ADDENDUM NO: 01

BID PACKAGE NO: Kitchen Work Rebid

PROJECT: North and South Decatur Jr. / Sr. High School Additions and Renovations

PROJECT NO: DATE: 02/16/2024 BY: Emery H. M. Hunt

DRAWING TITLE: UNDERSLAB PLAN - UNIT A -PLUMBING

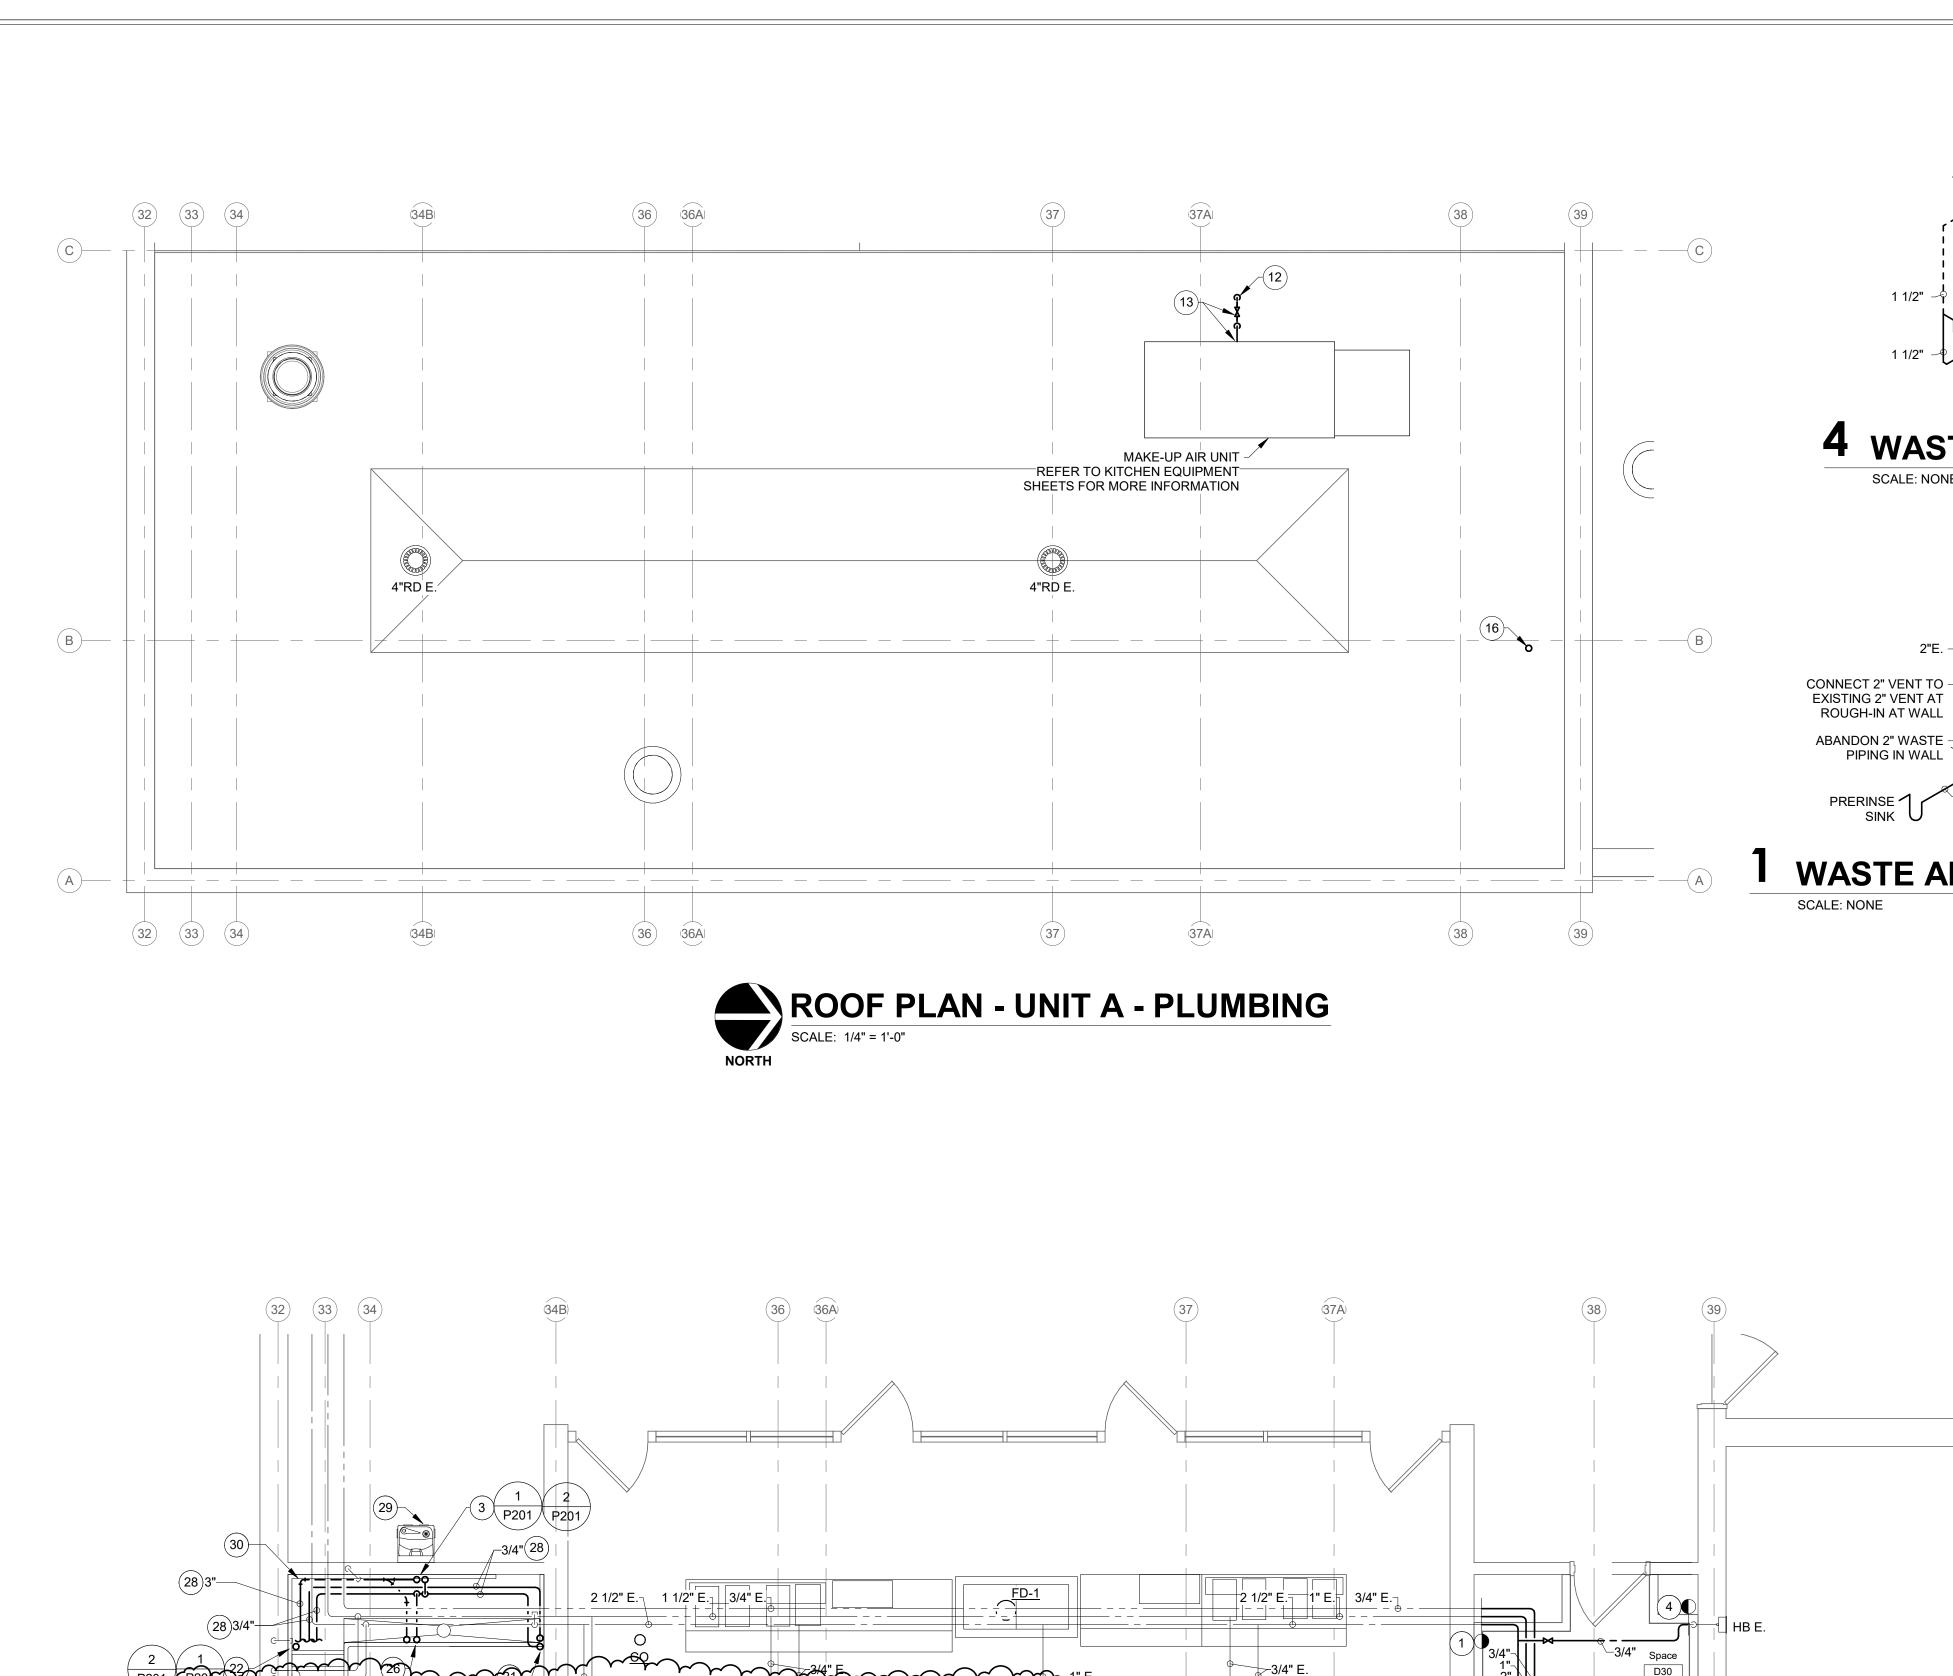
- A. Floor drain and related piping to remain along column line 36.
- B. Replace sheet in its entirety.

DRAWING TITLE: FIRST FLOOR PLAN - UNIT A -**PLUMBING**

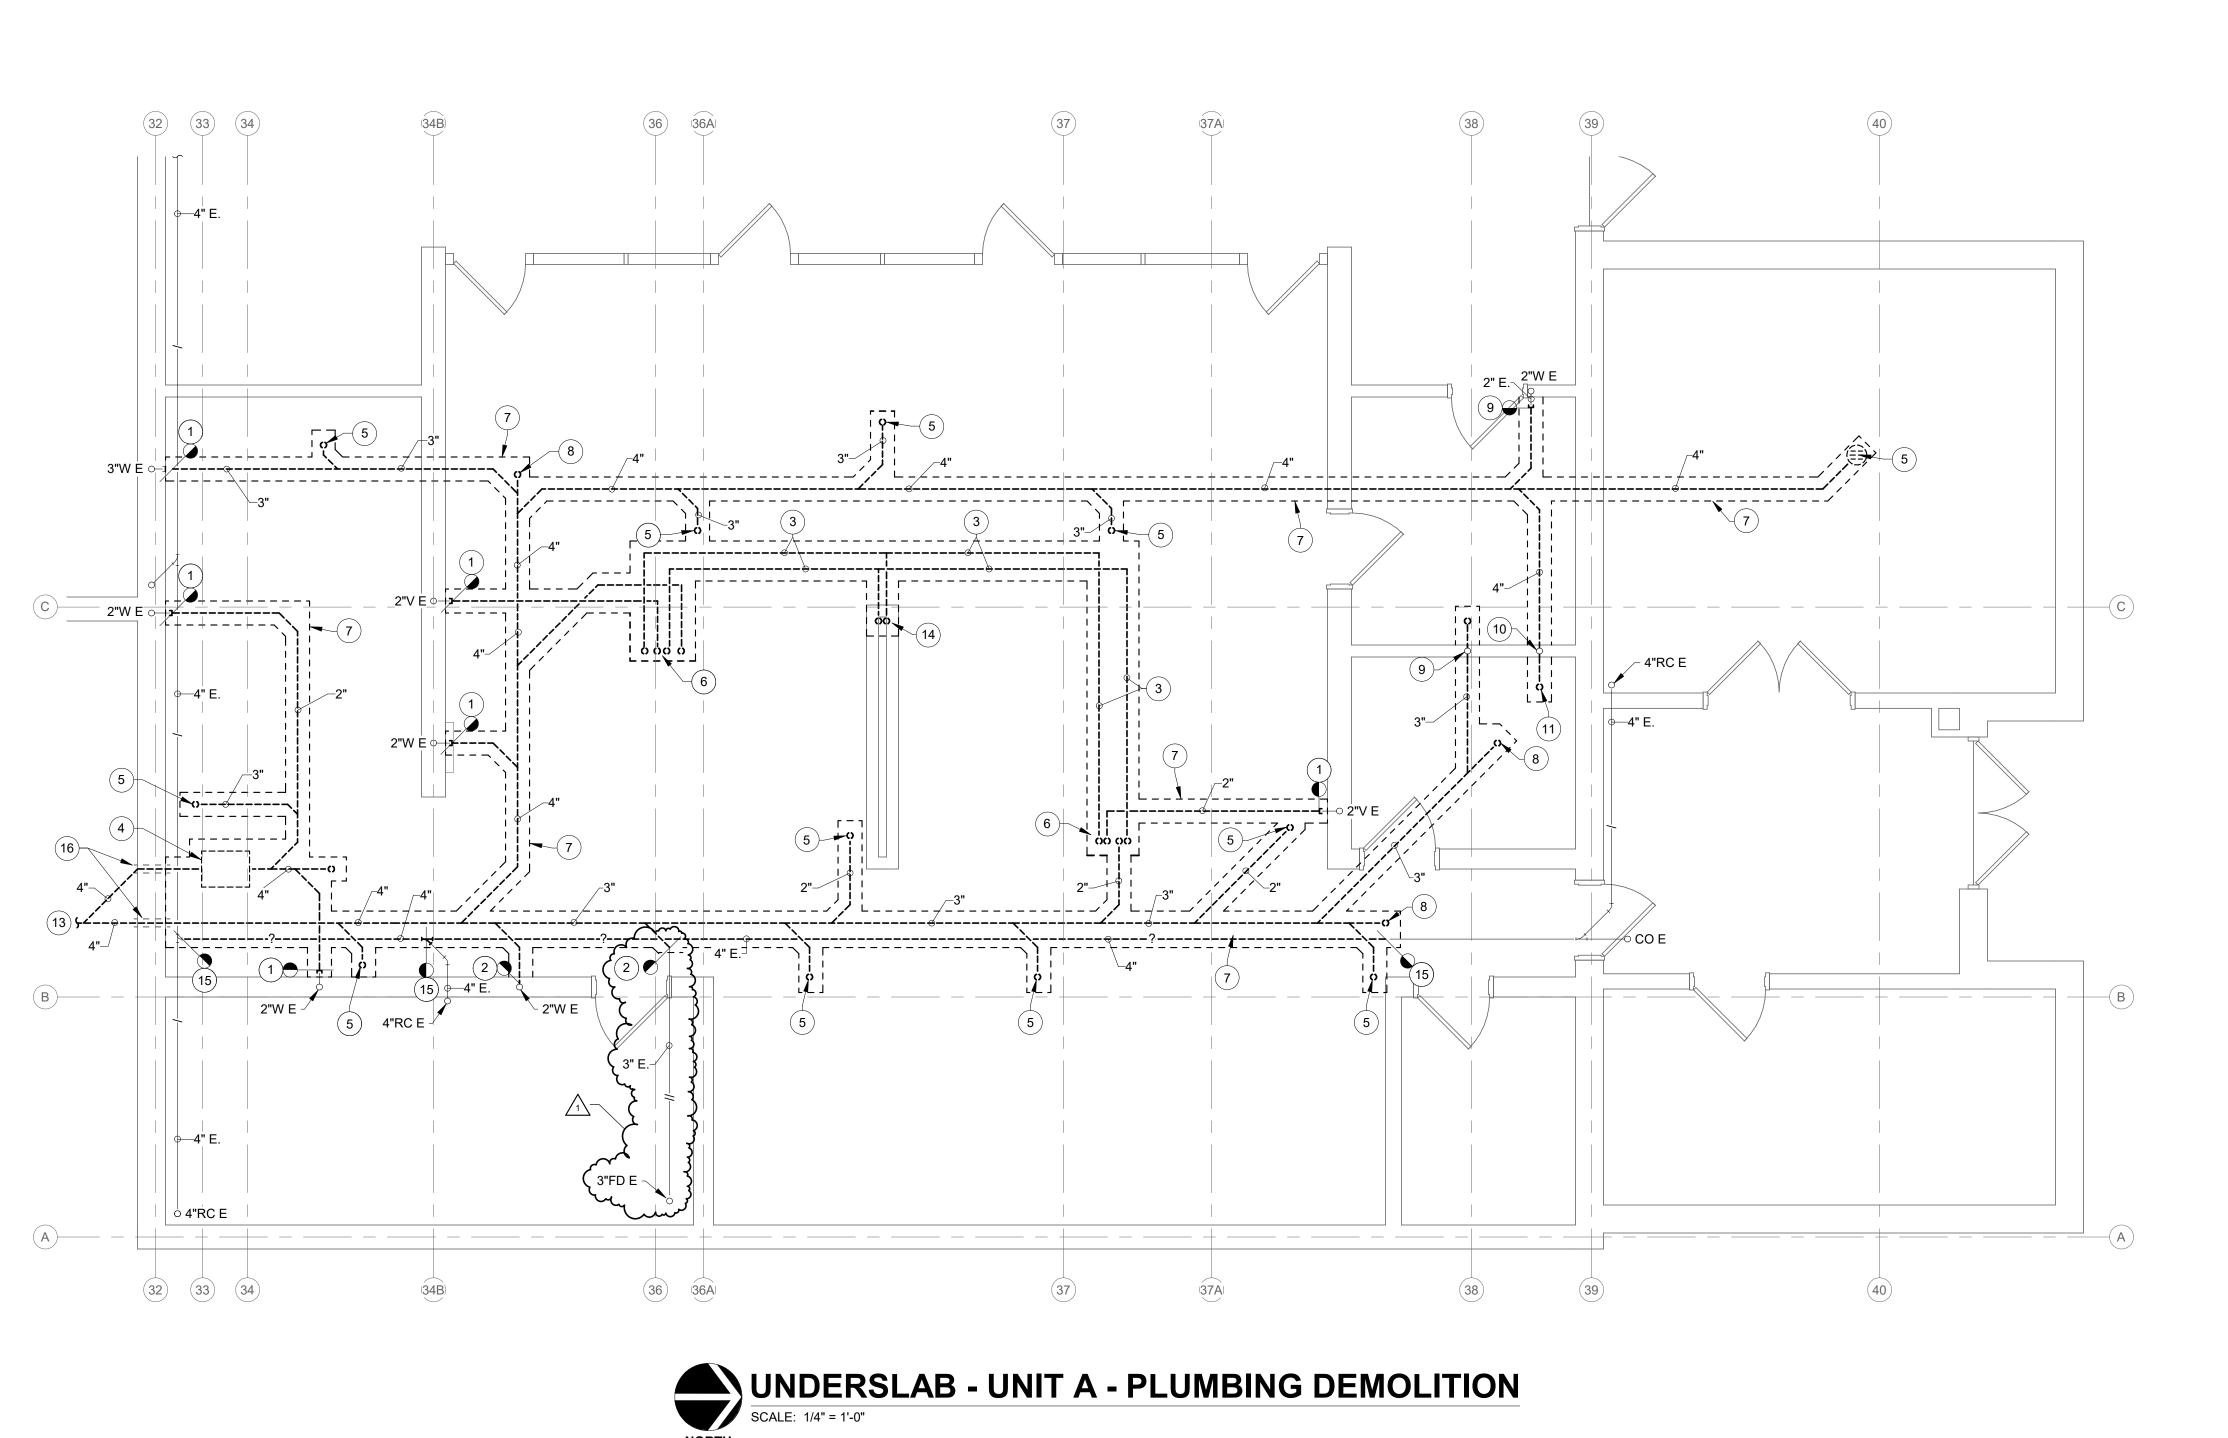
- A. Replace sheet in its entirety.
- B. Extend new 2 1/2" gas piping from admin mechanical room to kitchen hood. Route new 2 ½" gas piping in chase wall and connect to kitchen equipment. Tie-in location is approximately 45' to the south on the other side of the Teacher's Lounge. Remove and reinstall ACT ceiling as required to install pipe.
- C. Floor drain in dry storage room to remain.
- D. Change gas pipe size for make-up air unit.
- E. Revise plan note #10, 11, 12, 13, and 29.
- F. Add "GAS SERVICE NARRATIVE" to sheet.

DRAWING TITLE: UNDERSLAB PLAN - UNIT A -PLUMBING **DEMOLITION**

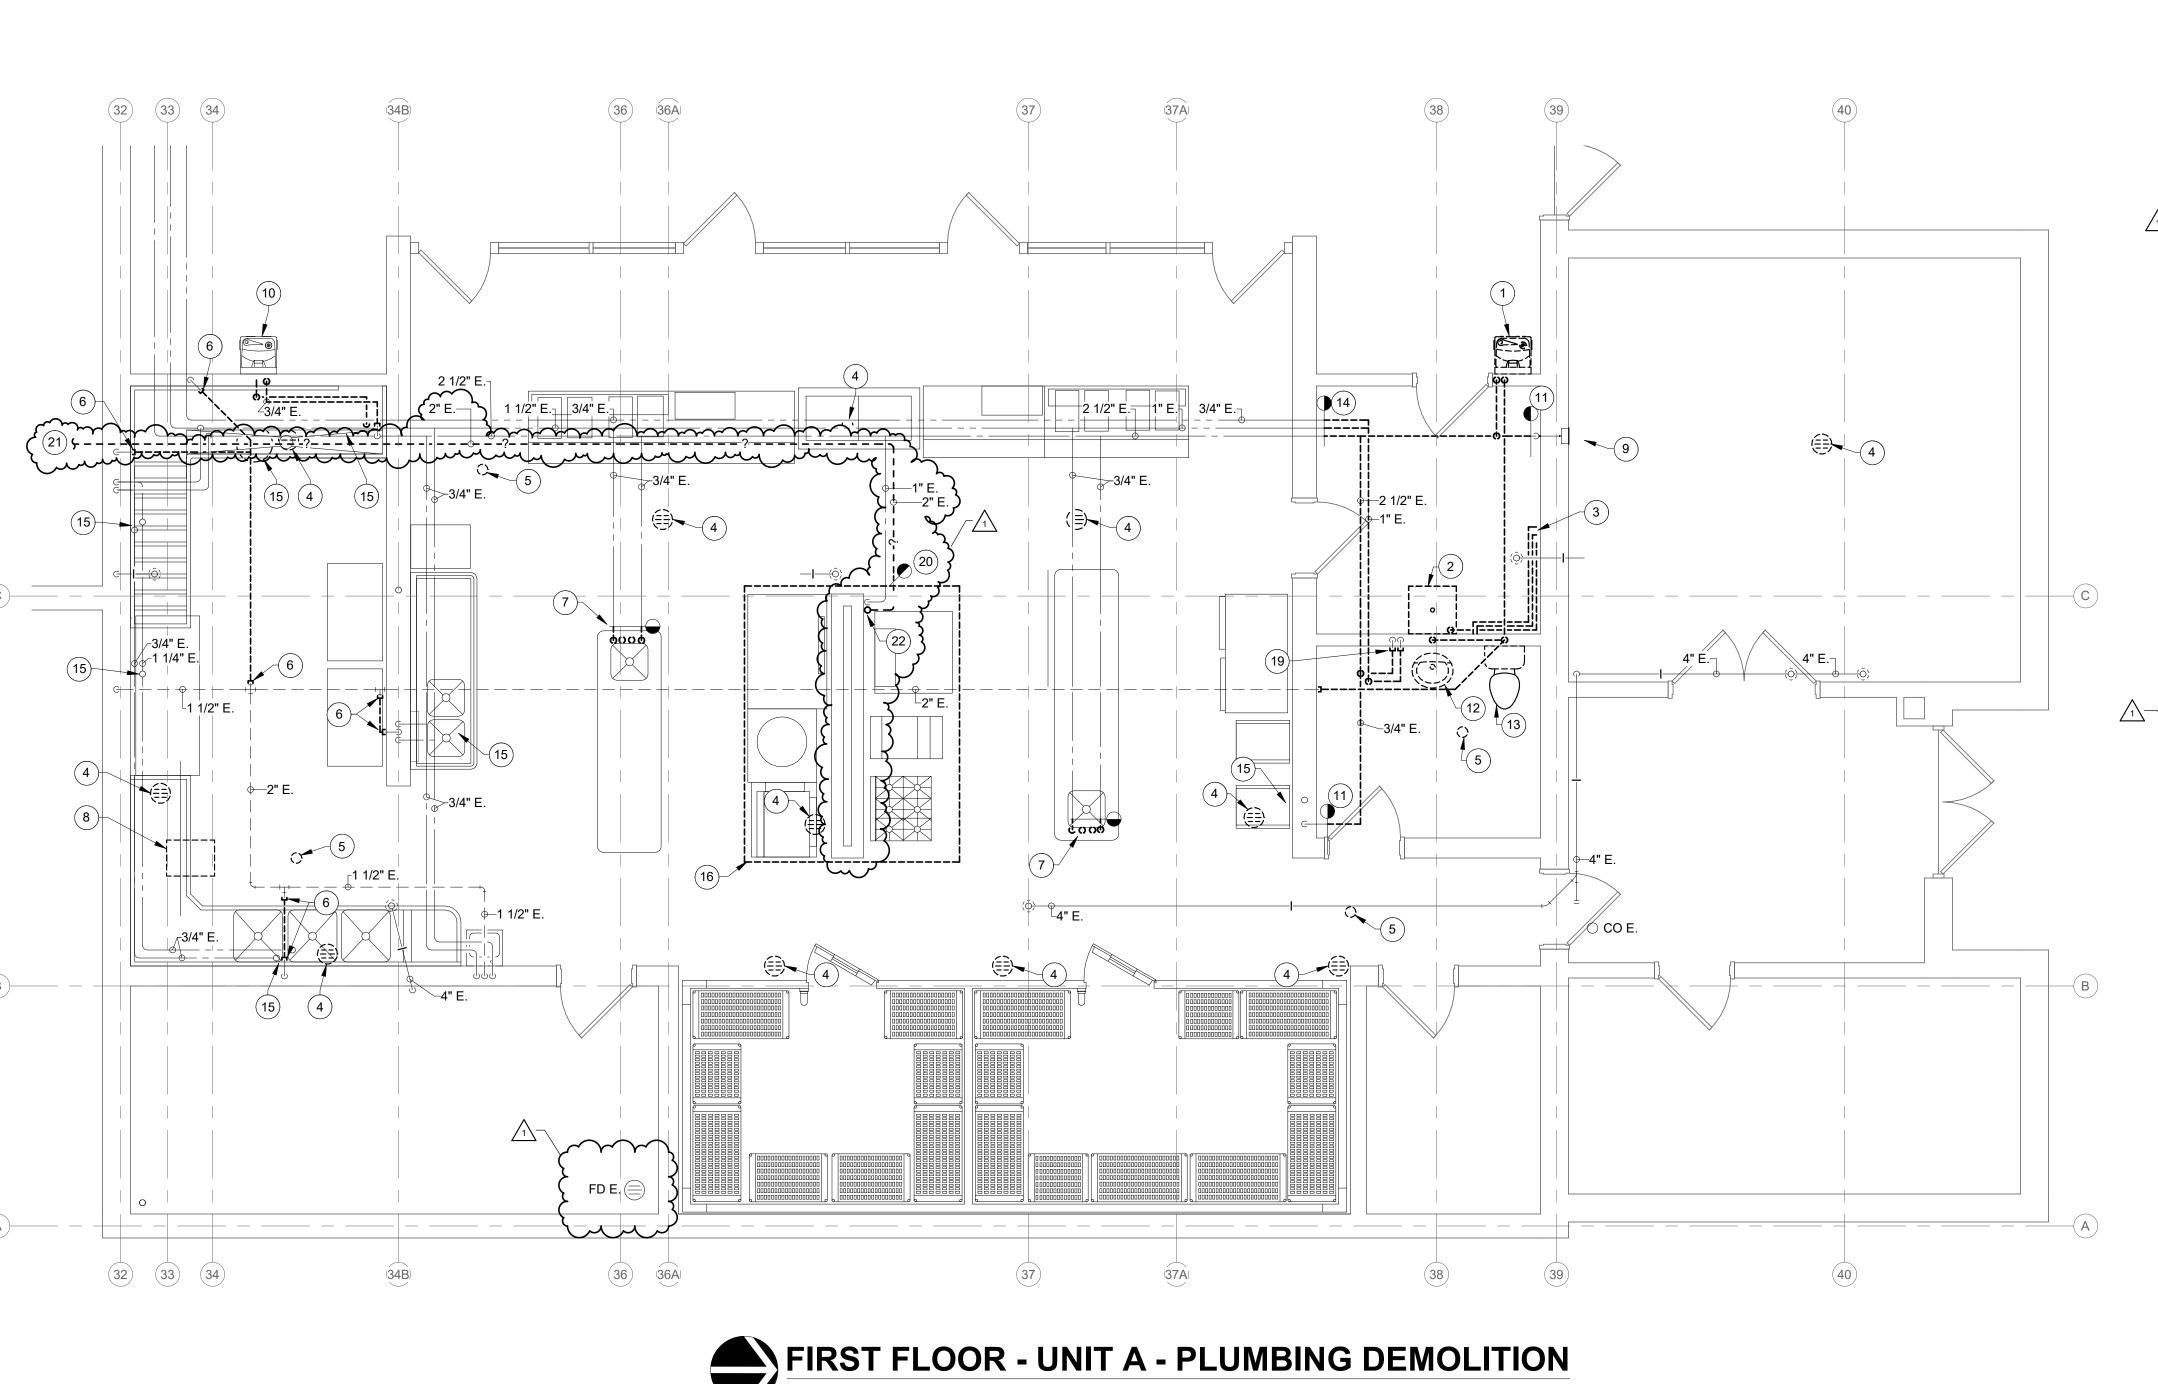
A. Replace sheet in its entirety.
